Landscape Review Committee
Community Development Center, 231 NE 5th Street
December 20, 2017
12:00 PM

DATE: December 20, 2017
TO: Landscape Review Committee Members
FROM: Chuck Darnell, Associate Planner
SUBJECT: Agenda Item 4A: L 43-17

An application for a landscape plan for a new parking lot on the north side of Cook School (L 43-17) to be reviewed by the Landscape Review Committee.

DECISION, CONDITIONS OF APPROVAL, FINDINGS OF FACT, AND CONCLUSIONARY FINDINGS OF THE MCMINNVILLE LANDSCAPE REVIEW COMMITTEE FOR APPROVAL OF LANDSCAPE PLAN FOR A NEW PARKING LOT AT 800 NE LAFAYETTE AVENUE

The landscaping being proposed can be seen below:

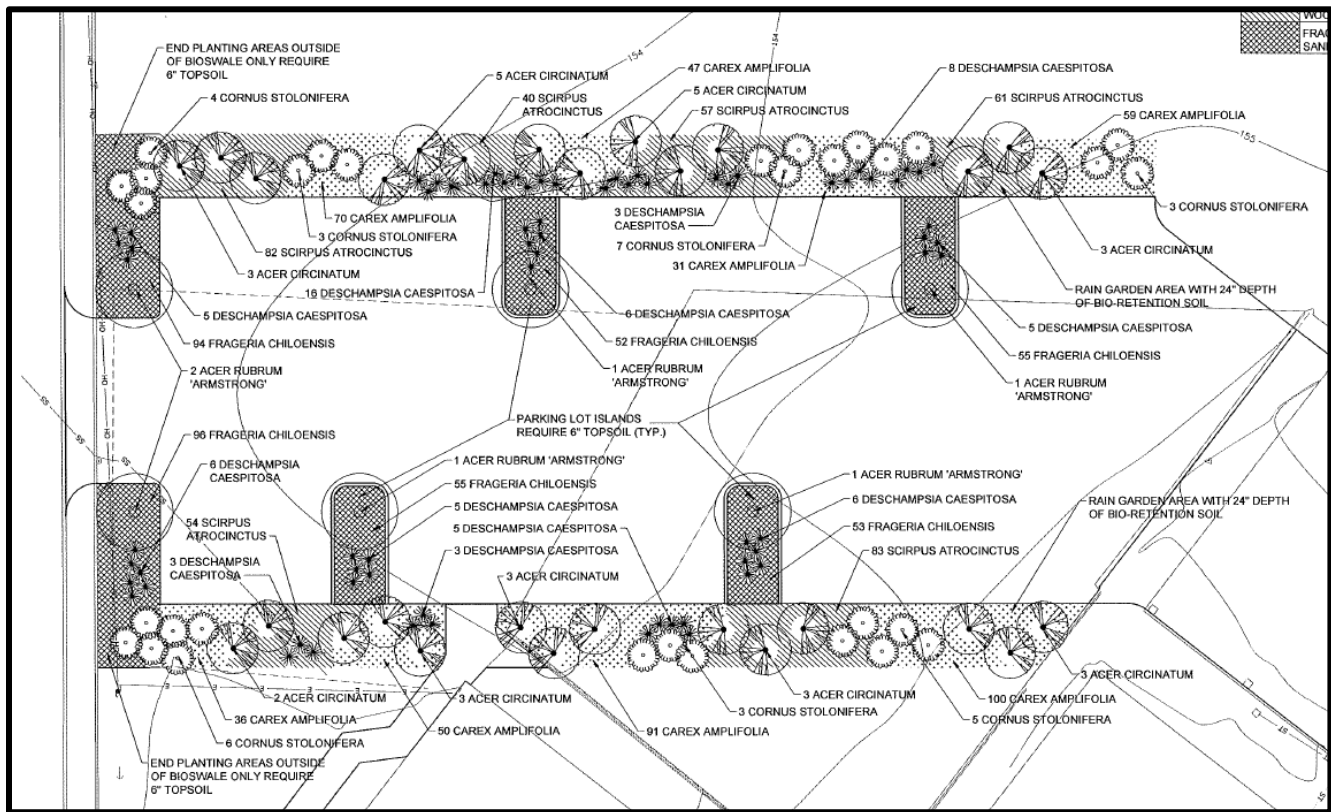
The Landscaping chapter of the McMinnville Zoning Ordinance requires that at least seven (7) percent of the gross area of a site being developed be landscaped (Section 17.57.050(A) (Area Determination – Planning Factors)). The landscape plan as proposed greatly exceeds those requirements, as 38 percent of the portion of the Cook School site that is being developed is proposed to be landscaped.

The proposed landscaping along the exterior borders of the new parking lot will include a variety of small trees, shrubs, and grasses, along with continuous groundcover plantings throughout the swale area. The trees and shrubs in these areas will include Vine Maple (*Acer circinatum*) and Redtwig Dogwood (*Cornus stolonifera*), with Golden Hanging Hair Grass (*Deschampsia caespitosa*) installed throughout the understory of the trees and shrubs. The trees and shrubs will be planted in a staggered pattern, and will alternate between groups of Vine Maples and Redtwig Dogwoods. The groundcover plantings will include Ample-Leaved Sedge (*Carex amplifolia*), Wool Grass (*Scirpus atrocinctus*), and Sand Strawberry (*Fragaria chiloensis*). The Ample-Leaved Sedge and Wool Grass will be alternating in the swale area, and the Sand Strawberry will serve as the groundcover plant in the planting islands and the areas between the parking lot and the public right-of-way on 9th Avenue.

1. That the applicant shall install landscaping as shown on the submitted landscape plan dated November 29, 2017.
2. That all landscaping approved by the Landscape Review Committee and required as conditions of approval shall be maintained, including necessary watering, weeding, pruning, mowing, and replacement.
